ADA Curb Ramp New Construction Inspection Form (Parallel)

NW 309th Ave

24952.54

NW Brooking Ct

PARALLEL RAMP (PL)

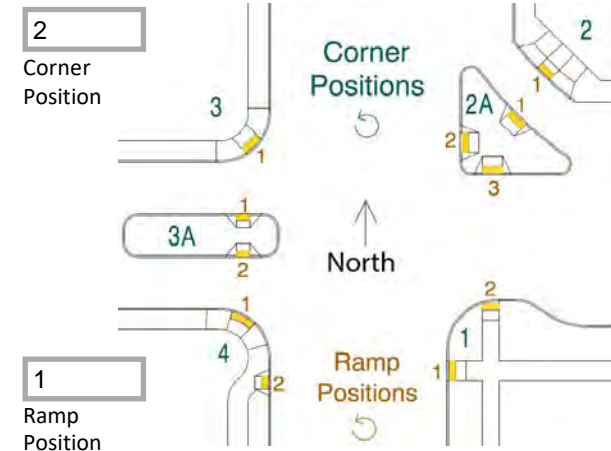
\leq 2.0% ☐ $>$ 2.0% ☒

4.1 \leq 2.0% ☐ $>$ 2.0% ☒

N Y ☐ N ☒

1.0 \leq 1/4" ☐ $>$ 1/4" ☒

☐ 9.78 \leq 8.3% ☐ $>$ 8.3% ☒

N Y ☐ N ☒

\leq 8.3% ☐ $>$ 8.3% ☒

4.2 \leq 2.0% ☐ $>$ 2.0% ☒

\leq 8.3% ☐ $>$ 8.3% ☒

4.3 \leq 2.0% ☐ $>$ 2.0% ☒

3.85 \geq 4.0' ☐ $<$ 4.0' ☒

4.1 \leq 2.0% ☐ $>$ 2.0% ☒

\leq 2.0% ☐ $>$ 2.0% ☒
